GFA AIRWORTHINESS DIRECTIVE

- TYPE AFFECTED:** SZD-38A 'Jantar 1'
- SUBJECT:** Replacement of the wing spar spigots at 1500 hours total time in service and the extension of the service life to 4500 hours total time in service.

PDPs "PZL-BIELSKO"	BULLETIN No BE-028/87 "JANTAR-1"	Page: 1 of: 3
BULLETIN No BE-028/87 "JANTAR-1" Ref: Life-time of SZD-38A "JANTAR-1" sailplanes Way of introducing: Obligatory when 1500 flying-hours have been completed. Elaborated in PDPs-TKS on 1987-01-20 Director of PDPs "PZL-BIELSKO" Dipl. Ing. J. CIEŚLA This is the translation of original Polish text approved by C.A.C.A. Translated by: Dr Ing. W. Stafiej

Ref: Extension of the life-time up to 4500 flying hours
for the SZD-38A "JANTAR 1" sailplanes on which the spar
root pins have been replaced acc. to the Bulletin
Nr BE-028/87 "JANTAR 1".

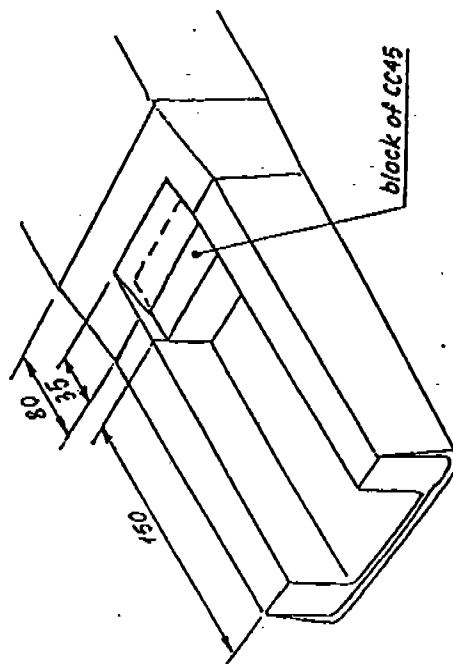
2.3. Using the face plate of the tool fit the pivot with block the cavity between the spar longerons and the wall (it should be fitted with no stressing).

2.4. Prepare the block of CC45 foam of 40 mm thickness and glue it up using the composition on the 160 mm length measured from the spar root.

This foam block is aimed to plug the space behind the duraluminium block against the excessive amount of the resin composition filled with the cut roving.

Close the opening in the pivot with the CC-45 foam plug.

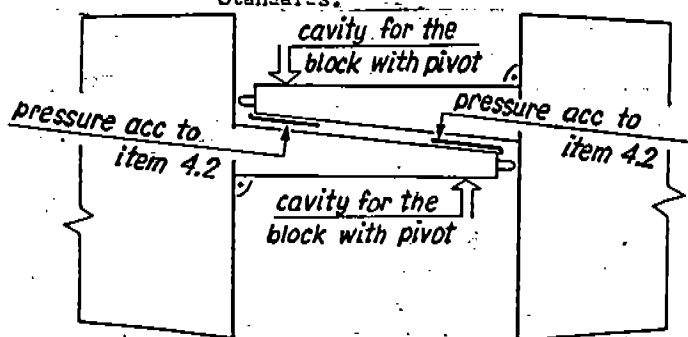
Glue on the 92110 X fabrics in such a way that it forms the "C-shaped" element till the arm of "C-shaped" element decreases to 2 mm. Then the last fabric layers

should be put flat. The ends of "C-shaped" and flat fabric elements should be glued with the 35 mm chamfered section.
